MSO9254A-03

S E R V I C E N O T E

MSO9254A - 2.5GHz Mixed Signal Oscilloscope

Repair for Windows "Power surge on hub" message

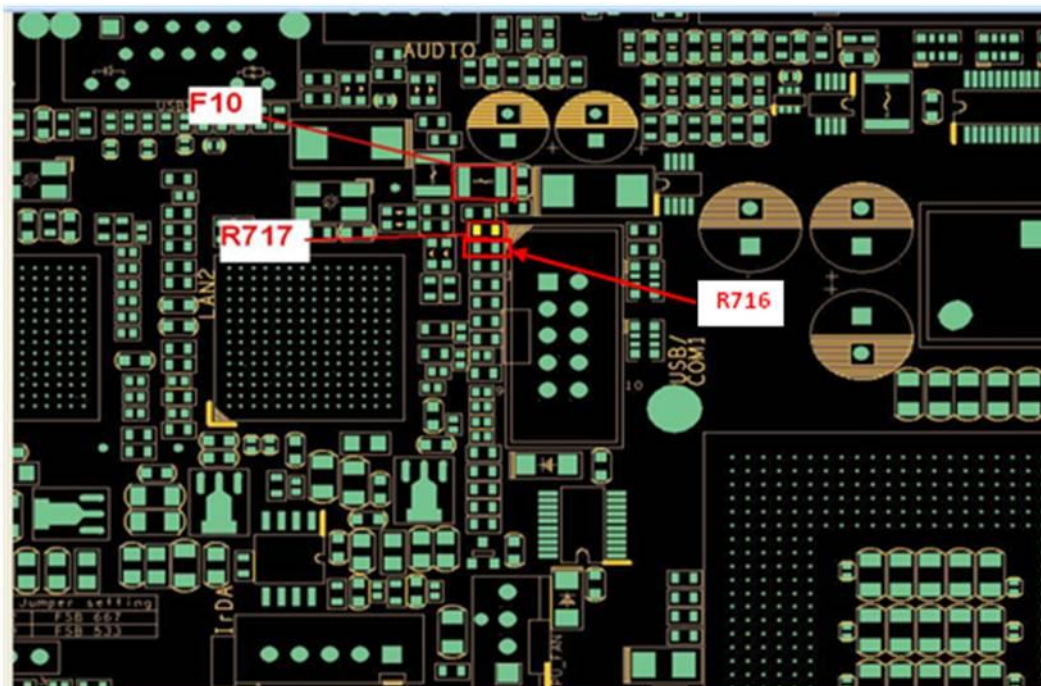
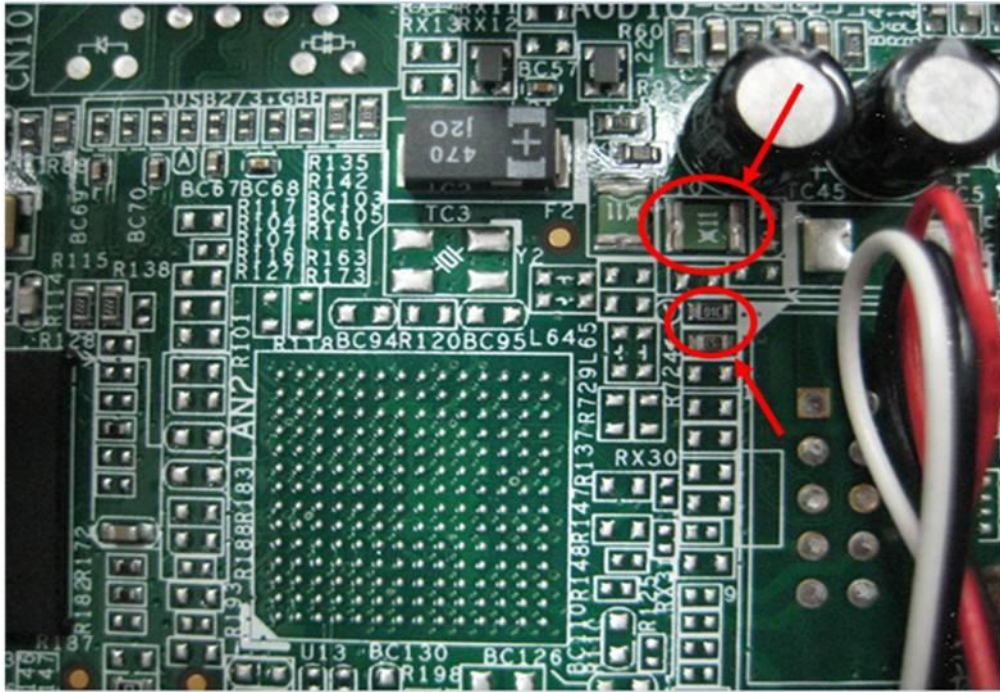
1. Refer to the service manual to remove the motherboard from the scope.
2. Install the three components from the upgrade kit on the motherboard. Refer to the below drawing and the drawing on the next page for component locations. The 0960-2789 motherboard is RoHS compliant and the below three components are also RoHS compliant. You should use a RoHS soldering station and RoHS solder techniques when possible.

F10 – 0837-3854 Thermistor

R717 – 0699-7654 10K Resistor

R716 – 0699-5789 15K resistor
